Countries: CANADA, UNITED STATES **Document ID:** IK1300169
Availability: ISIS, Bus ISIS, FleetISIS, NotSIR **Revision:** 0
Major System: TRANSMISSION **Created:** 12/5/2018
Current Language: English **Last Modified:** 12/6/2018
Other Languages: NONE **Author:** Gintarus Andriusis
Viewed: 136

Title: PSI 8.8L Gasoline Bus Lacking Power Climbing a Hill

Applies To: PSI 8.8L Gas bus

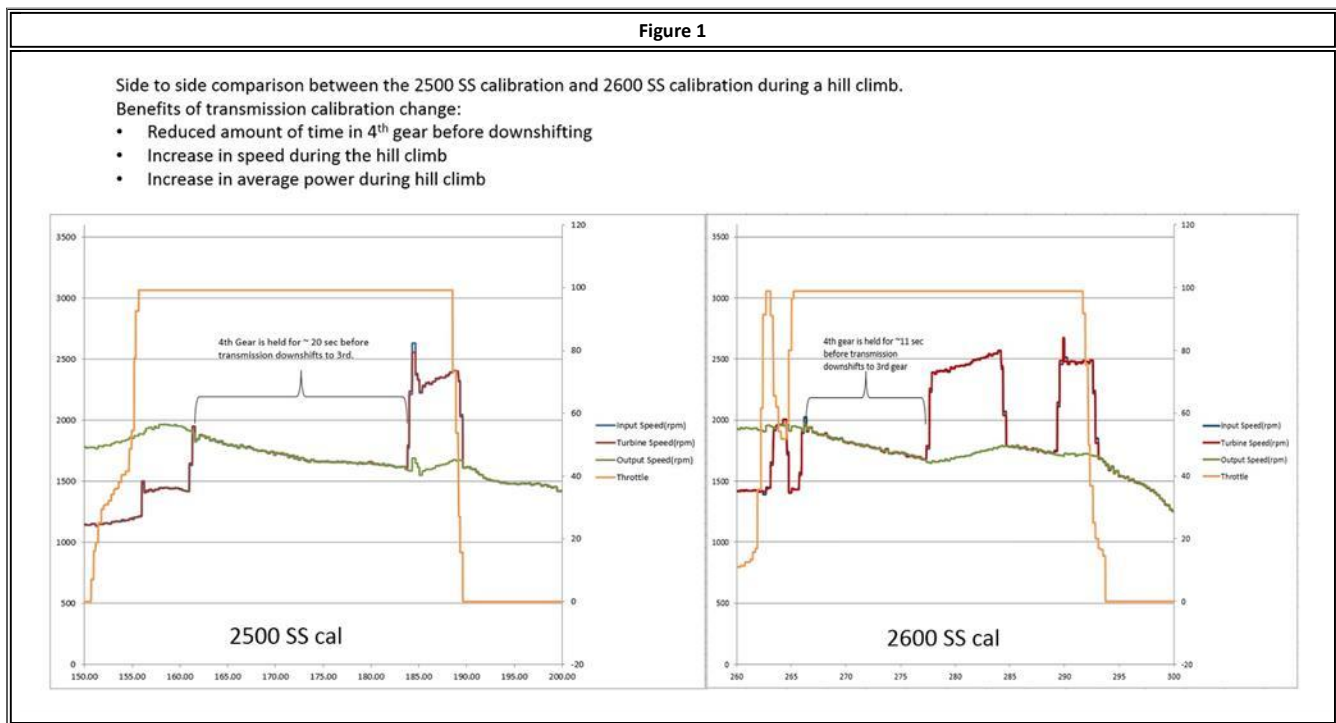
1. Bus will have to be taken to Allison shop
2. The transmission calibration will have to updated to 2600 Variable SS (from 2500 Variable SS) - Comparison shown in Figure 1
